DOCKET
10-BSTD-01

Re: AHRI Comments on December 9, 2010 Single Zone VAV Presentation at the Nonresidential HVAC Stakeholder Meeting #2 and April 21, 2011 CASE Report on Fan Control and Integrated Economizers (Docket Number 10-BSTD-01; April 27, 2011 Staff Workshop – 2013 Building Energy Efficiency Standards”)

Chart A

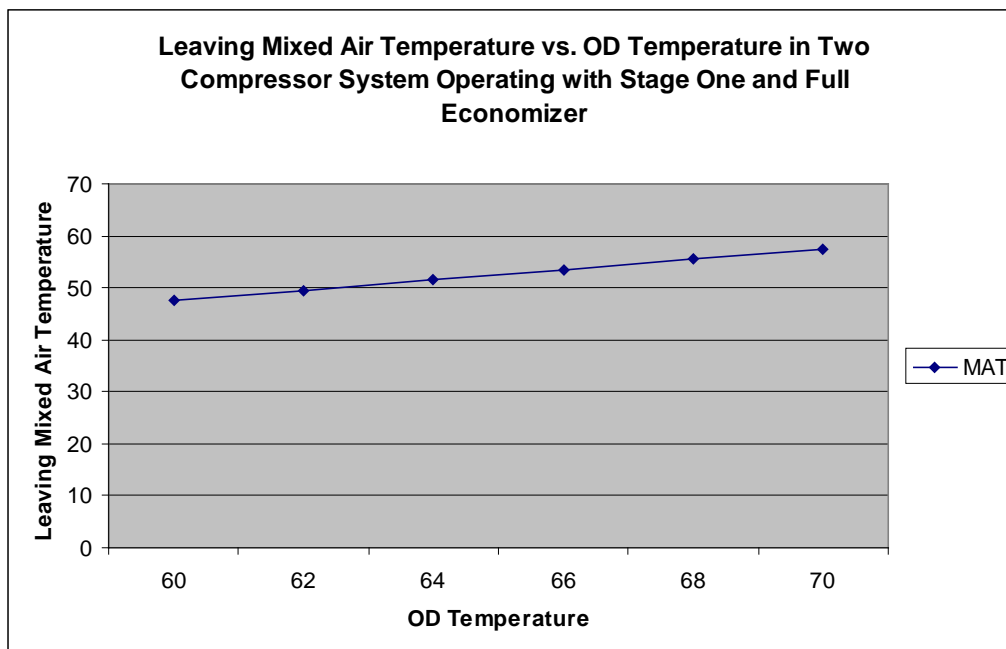
Chart A shows what the supply temperature would typically be if one stage of mechanical cooling is running in a two stage compressor unit, and the economizer is fully open at different outdoor temperatures with 50-60% relative humidity in the air.

Chart A suggests that the supply temperature could get below 50 °F when the outside air temperature is 60 °F. But there should be very few instances in typical applications, especially in the dry climate of California, when mechanical cooling is needed at an outside air temperature of 60 °F. We believe that most typical applications will not need mechanical cooling until the outside air gets closer to 65 °F. In this case, the economizer dampers do not need to close very often in order to maintain the supply air temperature above 55 °F.

Chart B

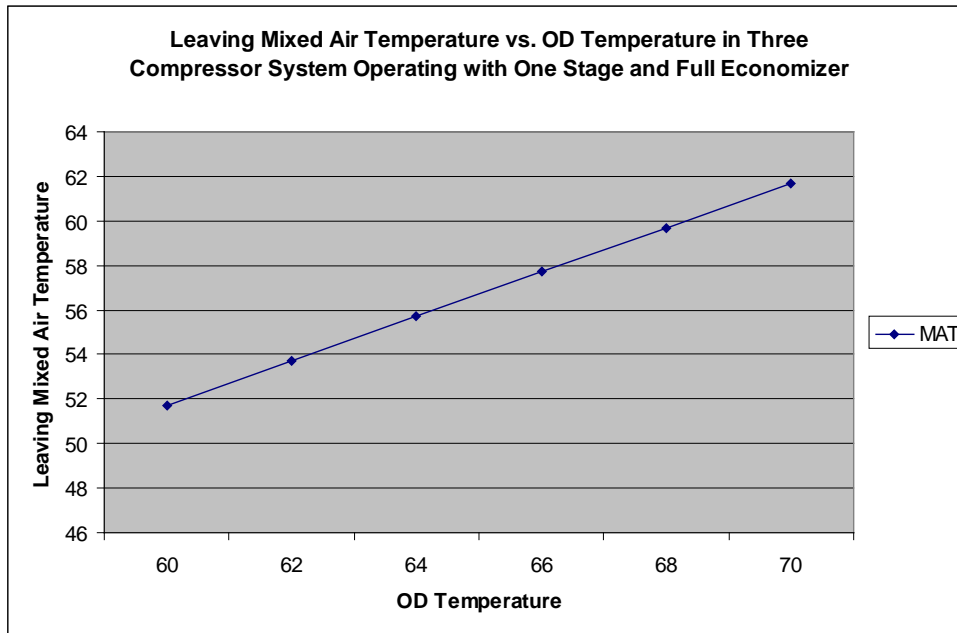
Chart B shows the supply temperature versus outdoor temperature for three-compressor units. The supply temperature for a three-compressor system only gets down to about 52 °F at an outdoor air temperature of 60 °F. There should be very few instances where the economizer dampers would close, even if the setpoint for closing the economizer dampers is 55 °F.

Chart C

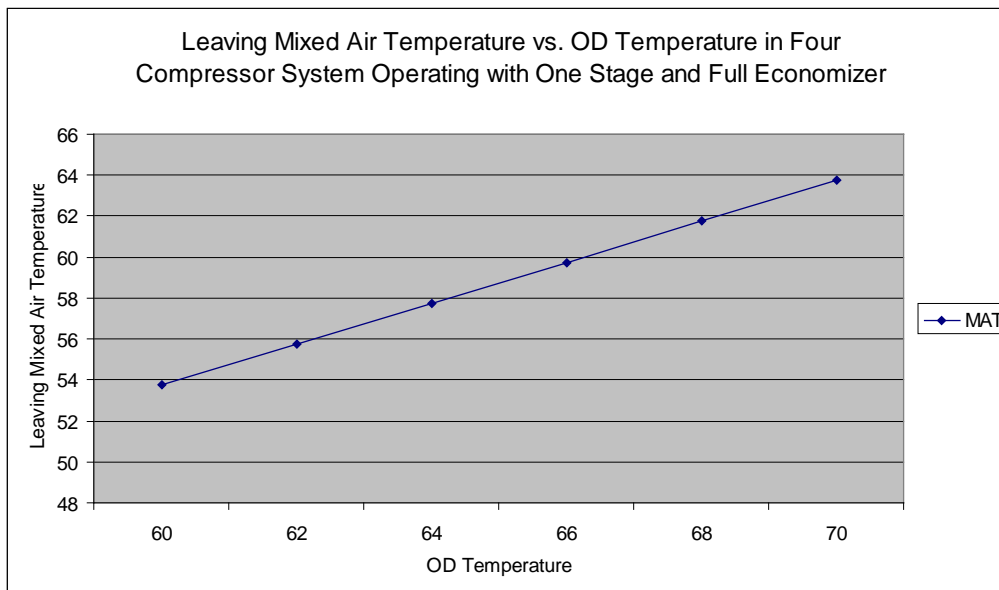
Chart C shows the supply temperature versus outdoor temperature for four-compressor units with face-split evaporator coils. At an outdoor air temperature of 60 °F, the supply is close to 54 °F. Therefore, the economizer dampers should seldom close when the outside air is 60 °F and suitable and the mechanical cooling comes on.
